National Cable & Telecommunications Association
25 Massachusetts Avenue, NW – Suite 100
Washington, DC 20001
(202) 222-2300

Re: ENERGY STAR[®] Specification for Set-top Boxes Version 4.1, Final Draft

Figure 1: Relative Energy Allowances of UHD Thin Client and UHD STB

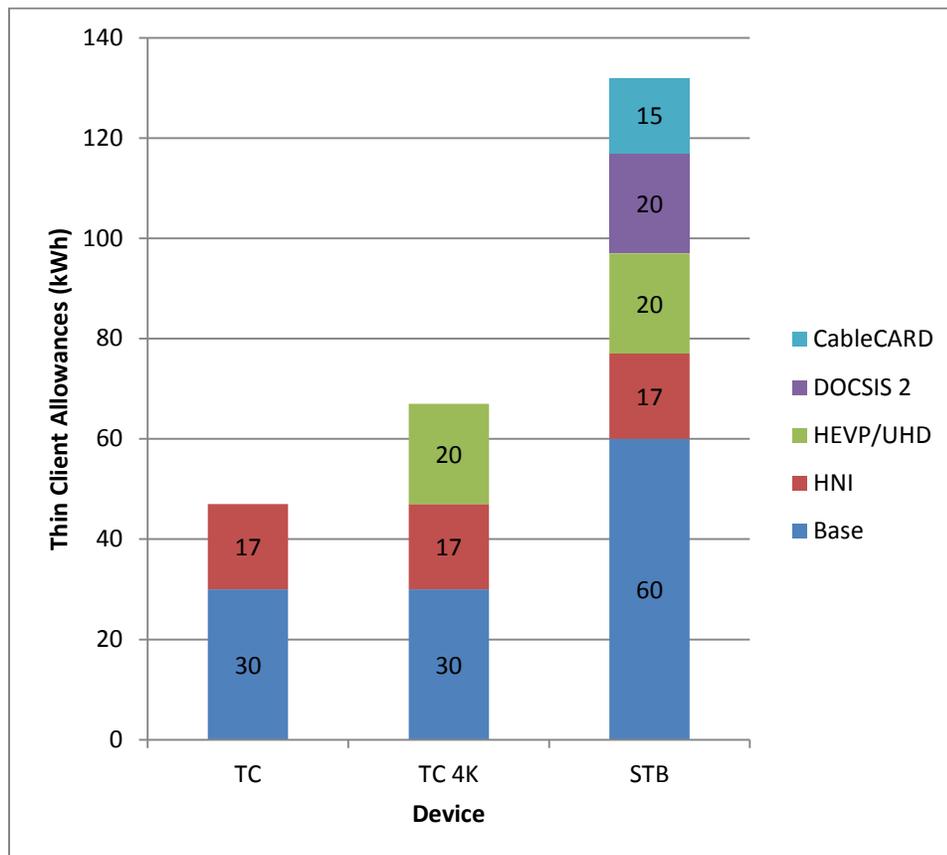
The final draft has proposed that thin clients should not qualify for Ultra HD or High Efficiency Video Processing (HEVP) allowances. This limitation would not allow thin clients to meet their functional requirements and would undermine the efforts of the EPA to support and promote gateway/whole home architectures.

We previously explained that to meet Service Provider performance requirements, thin clients must perform at the highest rate of resolution rather than the compressed, lower resolution video characteristic of OTT boxes. The EPA accepted this point in revising the base allowance to permit a TC to render HD video. But as the market begins to transition to UHD, thin clients must also have the opportunity to meet the standards for UHD in order for manufacturers and service providers to meet consumer demand. If thin client allowances do not permit a gateway/thin client architecture to deliver UHD to second and third televisions in the home, that limitation will create significant disincentives for the whole home architectures EPA wishes to promote. Consumers and service providers would need to rely upon a fully featured set-top box that is allowed UHD and HEVP allowances, which increases whole home energy use and does not serve the overall goal of energy efficiency, as shown in Figure 1.

We recommend that EPA modify Section 3.3.3 ii to permit Thin Clients to qualify for Ultra HD or High Efficiency Video Processing (HEVP) allowances.

Figure 2: Relative Energy Allowances of WiFi Thin Client and IAD

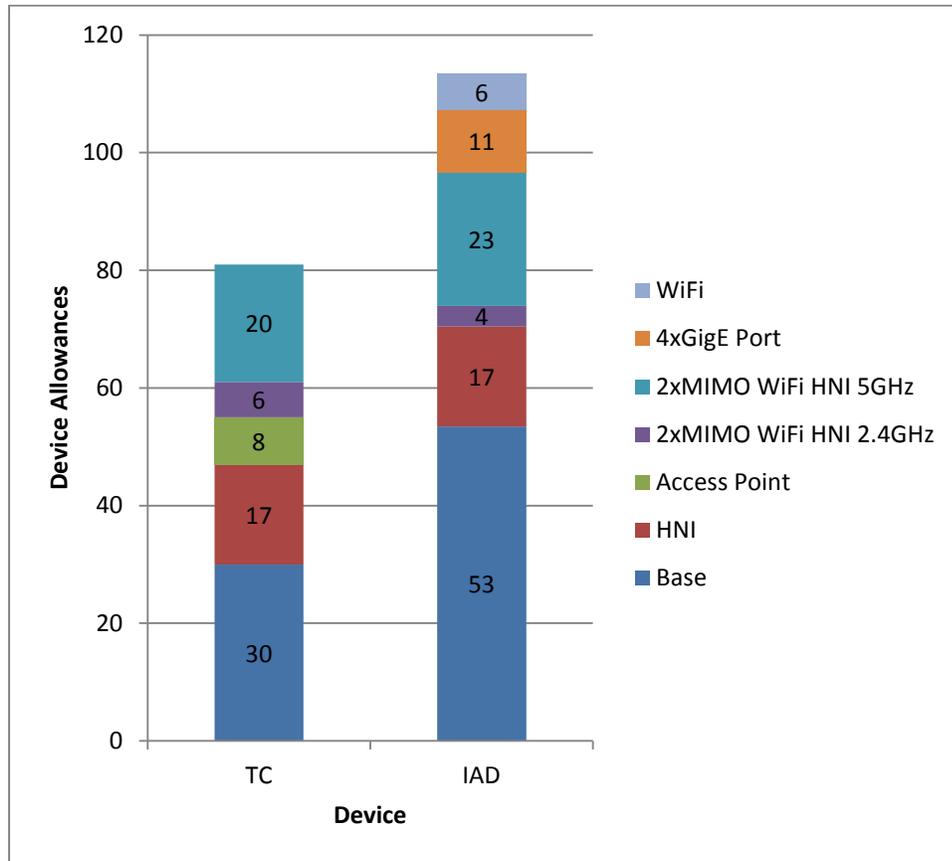
The final draft has also proposed that Thin Clients should not qualify as WiFi access points. Gateway/whole home architectures that support video and that penetrate the whole home need the flexibility to include more than one WiFi access point. Service providers serve a variety of household configurations, and some home configurations—such as premises with internal walls that limit signal penetration—will require some Thin Clients to also serve as a WiFi access point. Although this would not be in all households or even for all Thin Clients in a gateway/whole home architecture, if there is no potential for a Thin Client with WiFi capability, it would require consumers and service providers to rely upon a fully featured set-top box (shown in Figure 1) or an IAD (shown in Figure 2). Those choices increase whole home energy use and do not serve the overall goal of energy efficiency.

We recommend that EPA modify Section 3.3.3 ii to permit Thin Clients to qualify as a WiFi access point.
